PHILADELPHIA ELECTRIC COMPANY

March 30, 1988

SUBJECT: Peach Bottom Atomic Power Station
Diesel Generator Fuel Oil System
(TAC Nos. 47379, 47380)

REFERENCE: January 22, 1988 letter from
R. E. Martin, NRC, to E. G. Bauer, Jr., PECO

SCALE	DRAWN	ISS	DESIGNED	INCHES	APPROVED	DATE
1"=1'-0"	J. J. J.	J. J. J.	J. J. J.	1"=1'-0"	J. J. J.	11/11/55
SHEET 4 OF			12260-M-377-3

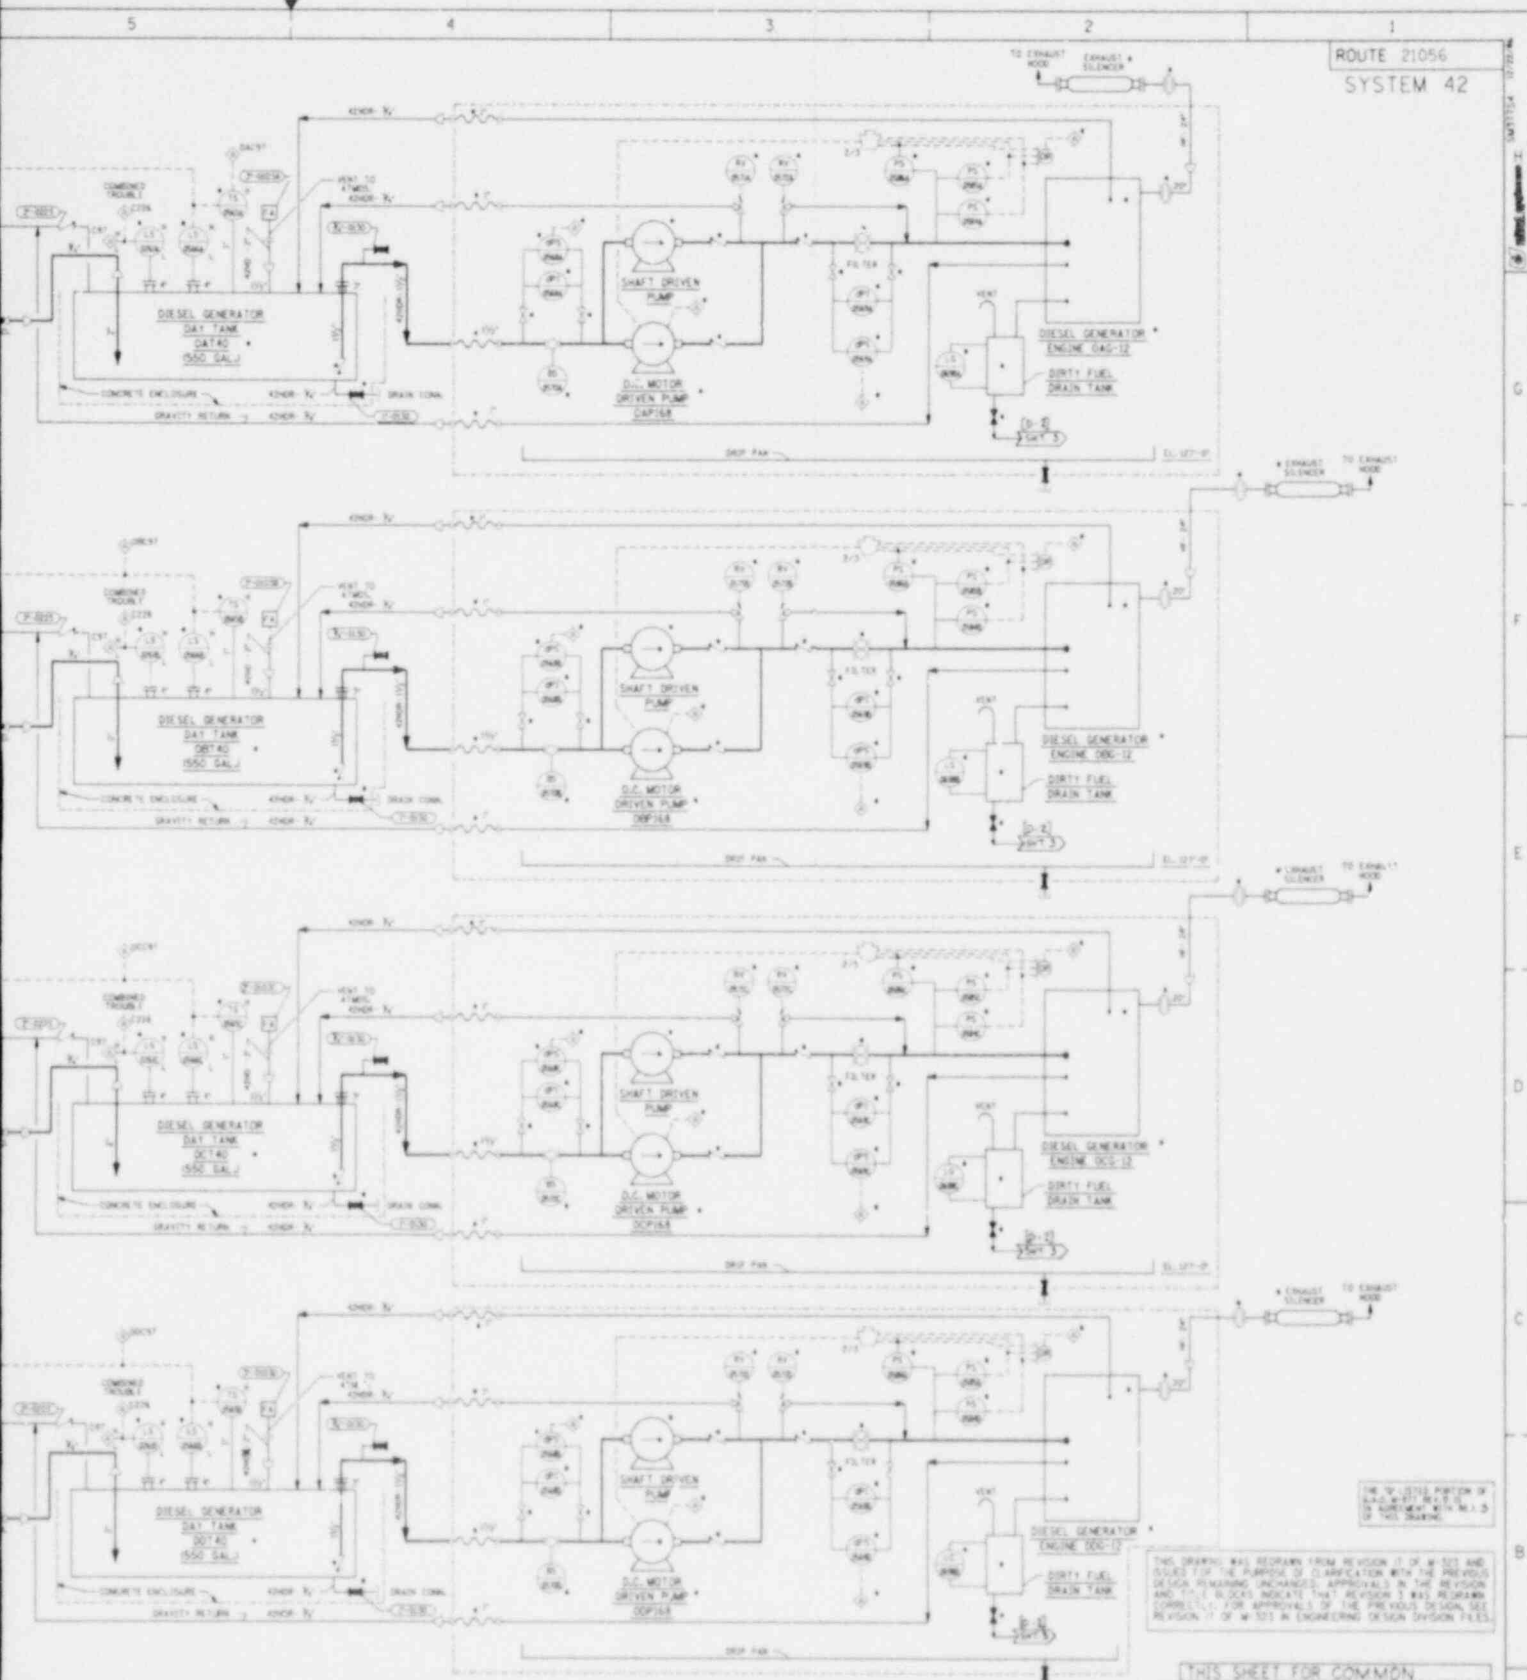
The licensee is requested to confirm that the diesel generator fuel oil system is, as apparently indicated by UFSAR Appendices C and D, included on the PBAPS Q-list and is designed to seismic Category I criteria.

The diesel generator fuel oil storage tanks, day tanks, transfer pumps, piping, pipe supports, and wye-strainers are included on the Peach Bottom Q-list. The applicable Q-numbers are 47.42, 47.43, 47.51, 47.53, 47.55 and 47.57, respectively. Furthermore, an itemization of each Q-listed component in the diesel generator fuel oil system is included on the new Q-list which was recently completed to provide a more detailed listing of Peach Bottom components. The new Q-List is currently undergoing final verification prior to issuance.

The diesel generator fuel oil system was designed to Seismic Category I criteria applicable at the time the plant was constructed. As shown on Bechtel Corporation piping isometric drawing FSK-M-433, all piping that is designated as "HDR" on P&ID M-323, Revision 13, is seismically analyzed by seismic span criteria and gravity spans. The information pertaining to the diesel generator fuel oil piping was transferred from P&ID M-323 to P&ID M-377, Sheet 4, during a recent computer aided design upgrade of the Peach Bottom P&ID's. The current revision of P&ID M-377, Sheet 4, is attached.
